Authors' response to the review of the manuscript titled "Modification, Calibration, and Performance of the Ultra-High Sensitivity Aerosol Spectrometer for Particle Size Distribution and Volatility Measurements During the Atmospheric Tomography (ATom) Airborne Campaign"; submitted to AMT on August, 9, 2017

**Reviewer #2** (received and published: 13 October 2017)

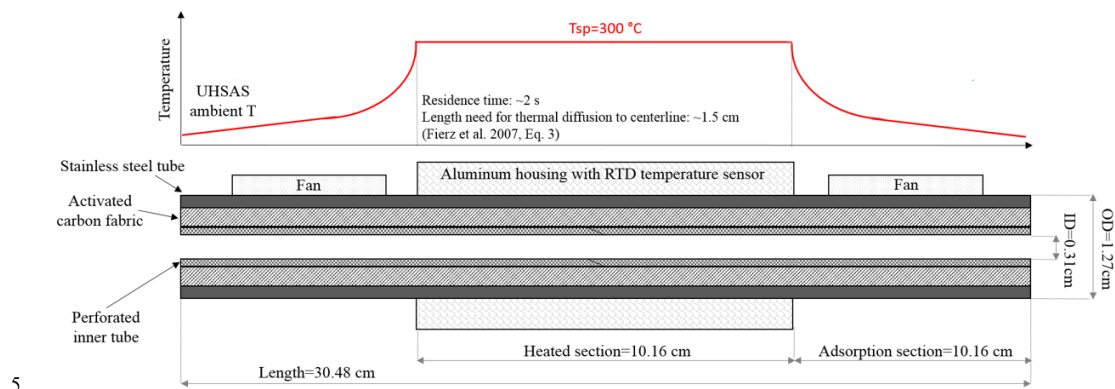
Figure 6: What are the grey, circular "cloud" shapes on each side of the heated section at the top of the figure?

We are not sure what the reference is to. This is what we see on our screen and printouts.
